Work Order ID 100023

Item Name: Crosstube Alt

DRAWING NO. D206-667-243	TITLE CROSSTUBE ASS'Y (206L HIGH AFT)	REV (.) REV C	DART AEROSPACE LTD ENGINEERING ORDER		DEO NO D206-667-243-C-1	SHEET NO SHEET 1 OF 1	SCALE NTS
DRAWN 97	CHECKED ASS	MFG. APPR. [Signature]	APPROVED [Signature]		DE APPR. [Signature]		
DATE 11.07.15	DATE 11.07.20	DATE 11.07.21	DATE 11/07/21		DATE 11.07.21

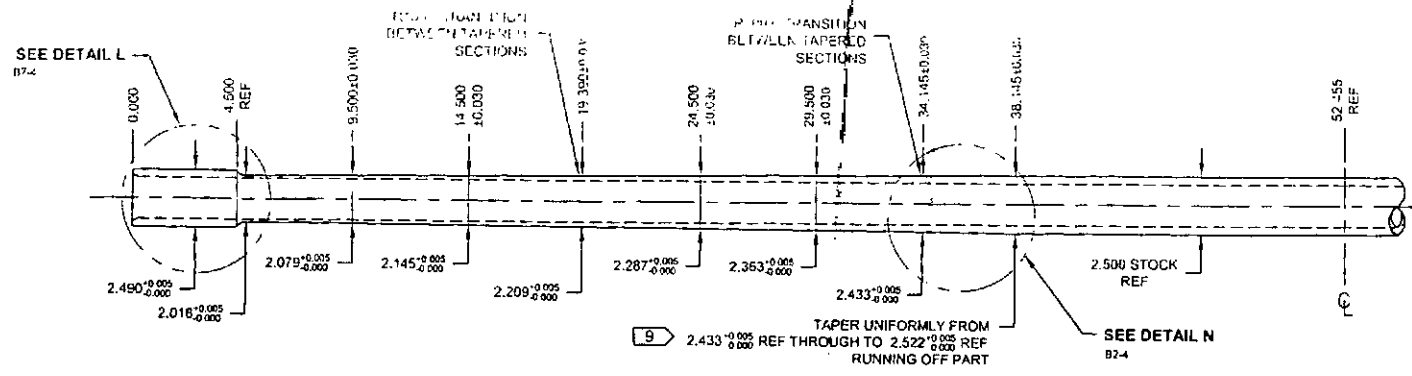
REPLACE MAGNOBOND WITH PROSEAL.

NOTE 12 & 15, SHEET 1 IS AMENDED AS FOLLOWS:

- 12) TO INSTALL D2892-1 SUPPORT: ABRASE MATING SURFACE OF SUPPORT AND CROSSTUBE WITH 180-GRIT SANDPAPER AND REMOVE RESIDUE WITH MEK (OR EQUIVALENT). APPLY A 0.04" TO 0.07" THICK LAYER OF PROSEAL 890 CLASS B-2 (OR AMS-S-8802 CLASS B-2) SEALANT TO MATING SURFACE OF SUPPORT.
- 15) TORQUE CLAMPS 80 TO 100 IN-LB. ENSURE AT LEAST 1.5 THREADS SHOWING IN SAFETY AND THAT NUT HAS NOT BOTTOMED-OUT AFTER TORQUING. PRIOR TO PACKAGING, RE-CHECK TORQUE ON CLAMPS AFTER PROSEAL 890 SEALANT HAS CURED FOR 72 HOURS.
